# YAESU FP707-FP757

## PSU REPAIR

Q103 UNDERSIZED

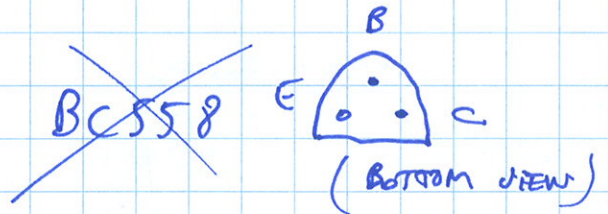
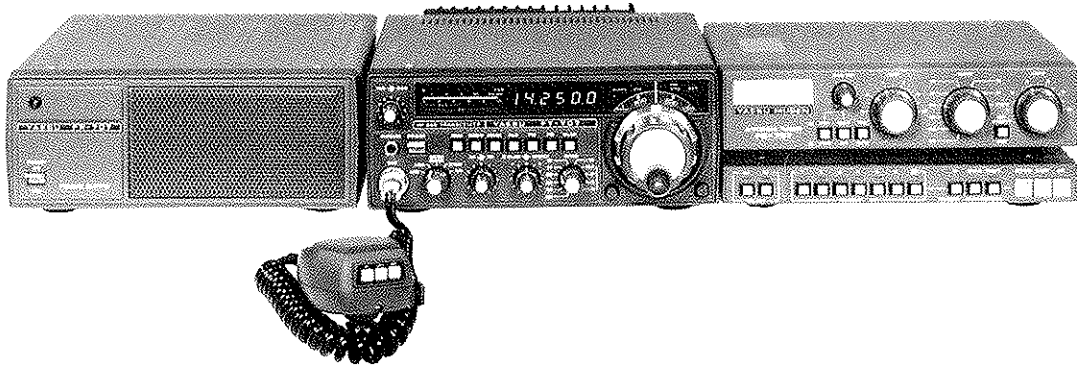
— "another" design issue

(SYMPTOM: 22V output  
in stead of 13,8V)

→ ~~PNP BC558~~  
> 300 mA  $I_{C_{max}}$

"WAS" 2S4550

↳ fails regularly!

BC369

→ do NOT replace by "universal" NPN like BC558

→ too weak, needs HIGH  $I_c$  NPN like BC369

(bend middle collector leg to other side to fit PCB)
